ADDENDUM NO.1

SULLIVAN MIDDLE SCHOOL ATHLETIC RESTROOM/CONCESSION BUILDING

ROCK HILL SCHOOLS
BID PACKAGE 1:
BID # 19-2024 SITE PREPARATION & UTILITY CONNECTIONS

February 25, 2020	VOLUME 1 OF 1	APN # 593120
-------------------	---------------	-----------------

C4.0

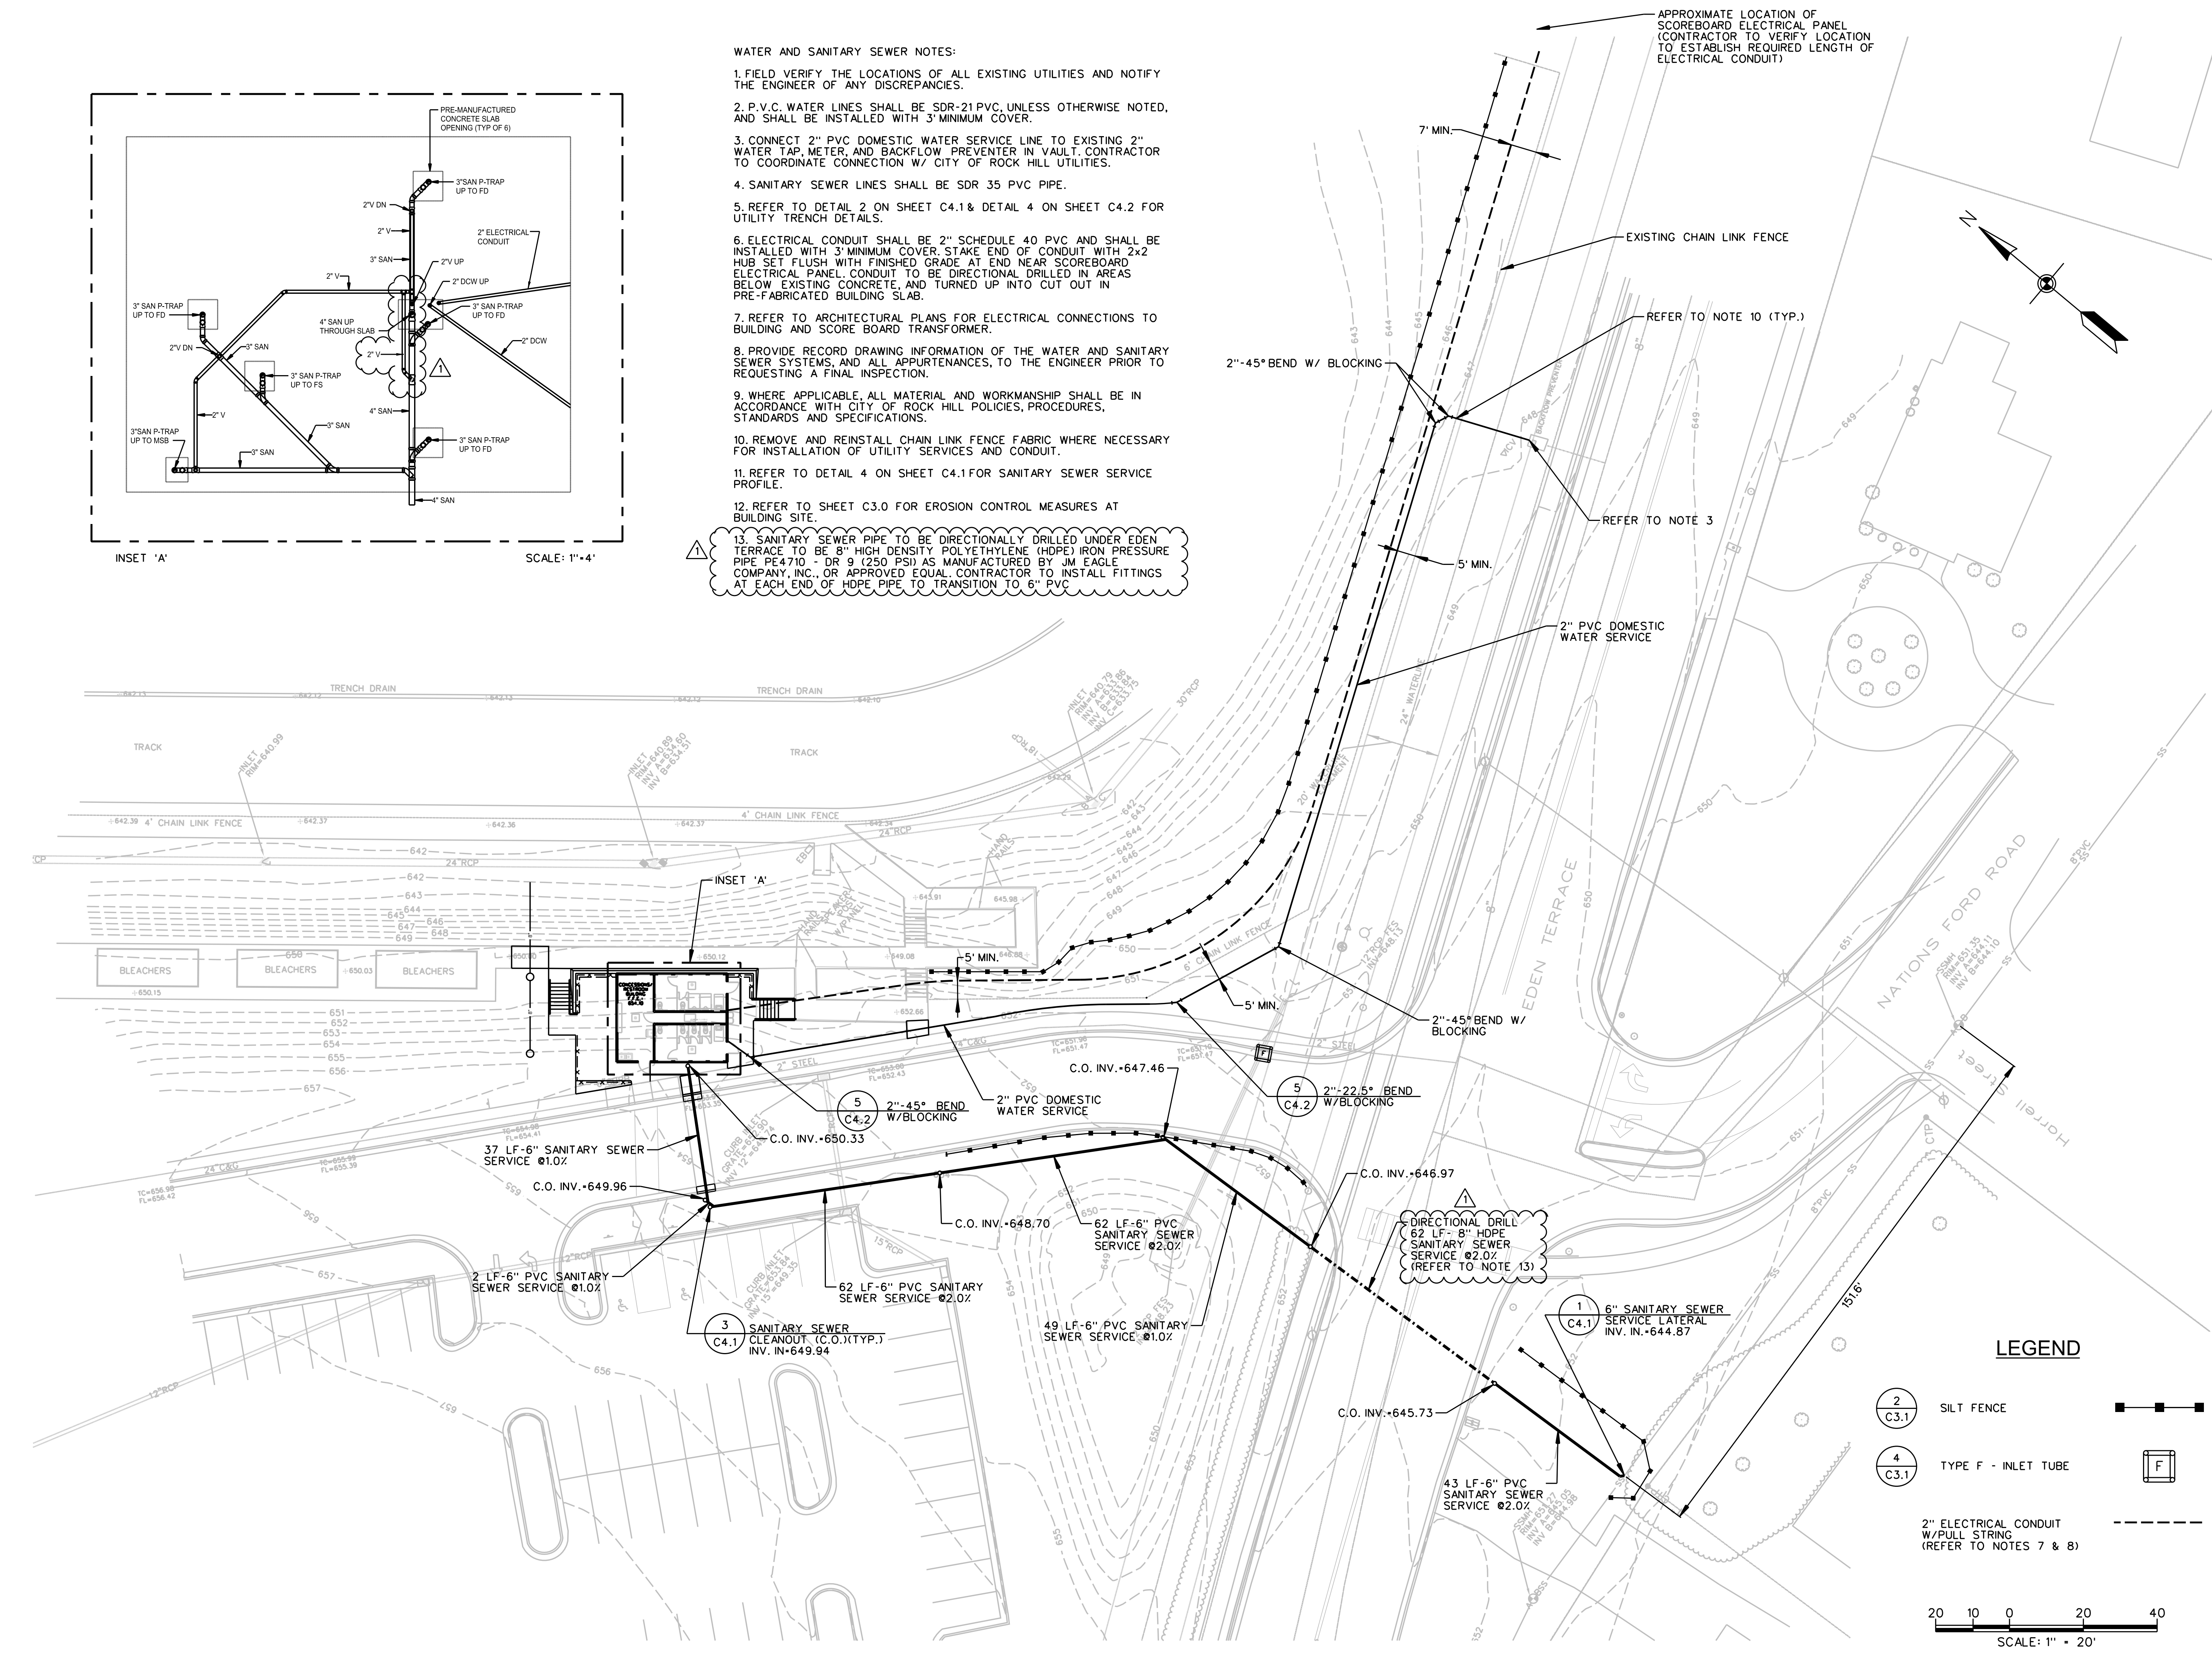
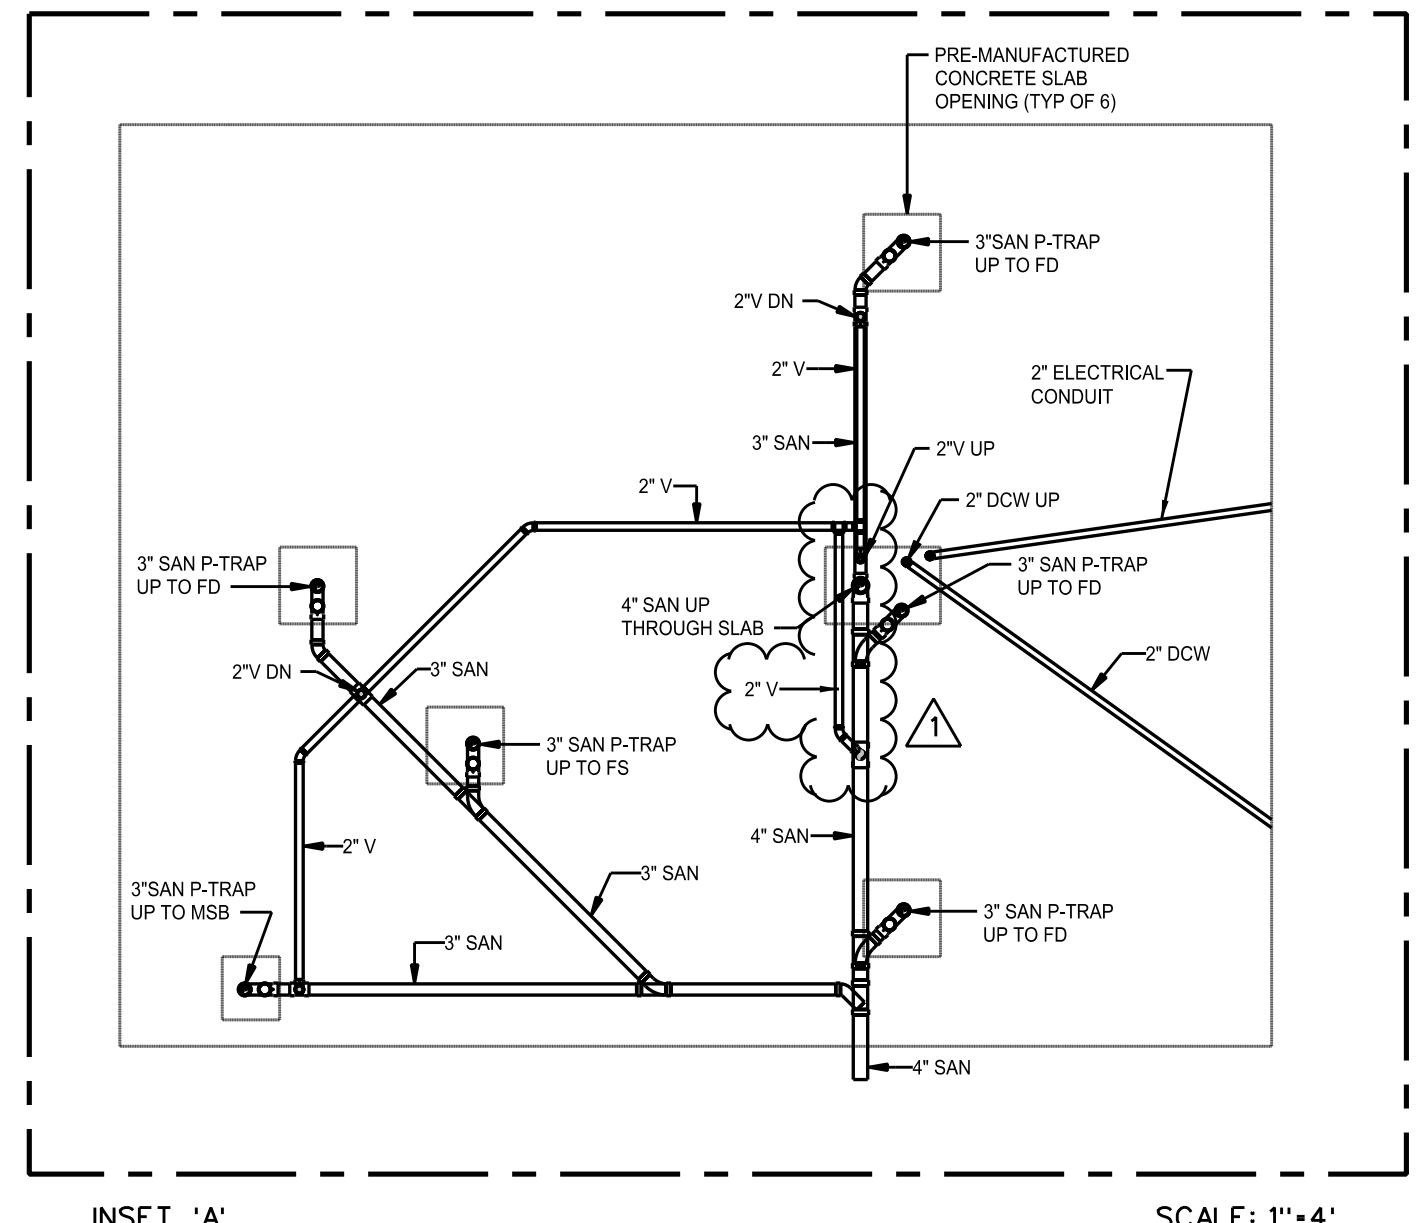
- 1) On sheet C 4.0 and C 4.1, the design indicates the 6" PVC sewer line changes to an 8" HDPE for the distance of the directional bore under Eden Terrace and then back to 6" PVC to final connection. We do not understand how this will work, why the change in pipe size and materials is necessary. We do not believe the City of Rock Hill would approve this design. Please explain the methodology for changing pipe sizes and materials and if CRH approval for this design has been permitted.
 - a. The 8" HDPE pipe for directional drilling is to be DR 9 (250 PSI), which has an inside diameter of 6.59". This is the closest size available that provides an inside diameter equal to or slightly larger than the ID of the PVC sewer service pipe. The HDPE pipe has fittings available to transition between the pipe types.

- 2) The sanitary sewer profile on sheet C 4.1 indicates very close clearances between the existing gas/water mains and the proposed sewer directional bore. How much research was put into determining the exact location of the existing lines, and who is responsible, or what alternative methods would be employed if these lines do not permit a safe installation of the directional bore?

- 4) On page C4.0, the directional bore shows 8" HDPE at 2% is that a sleeve? The sewer is 6" SDR35 everywhere else.
 - a. See response to Civil Question #1 regarding the HDPE section of pipe.

13. SANITARY SEWER PIPE TO BE DIRECTIONALLY DRILLED UNDER EDEN TERRACE TO BE 8" HIGH DENSITY POLYETHYLENE (HDPE) IRON PRESSURE PIPE PE4710 - DR 9 (250 PSI) AS MANUFACTURED BY JM EAGLE COMPANY, INC., OR APPROVED EQUAL. CONTRACTOR TO INSTALL FITTINGS AT EACH END OF HDPE PIPE TO TRANSITION TO 6" PVC

- a. Note #1 on sheet C4.0 directs the contractor to field verify the locations of all existing utilities and to notify the Engineer of any discrepancies. The proposed slope of the HDPE pipe crossing Eden Terrace and the remaining portion of 6" PCV pipe connecting to the existing sanitary sewer main is 2.00%. The minimum slope for a 6" service line is 1:00% If the field locates of the existing 8" water main and the 6" natural gas line are deeper than shown, the slope of these two sections of pipe could be reduced to that 1.00% slope to clear those conflicts. Within this 105 LF of the sewer service line, reduction of the slope to 1.00% would lower the invert of the cleanout at the school side of Eden Terrace to 645.92. A vertical drop can be installed at this cleanout to set up for the installation of the 6" D.I. pipe crossing over the 24" water main.
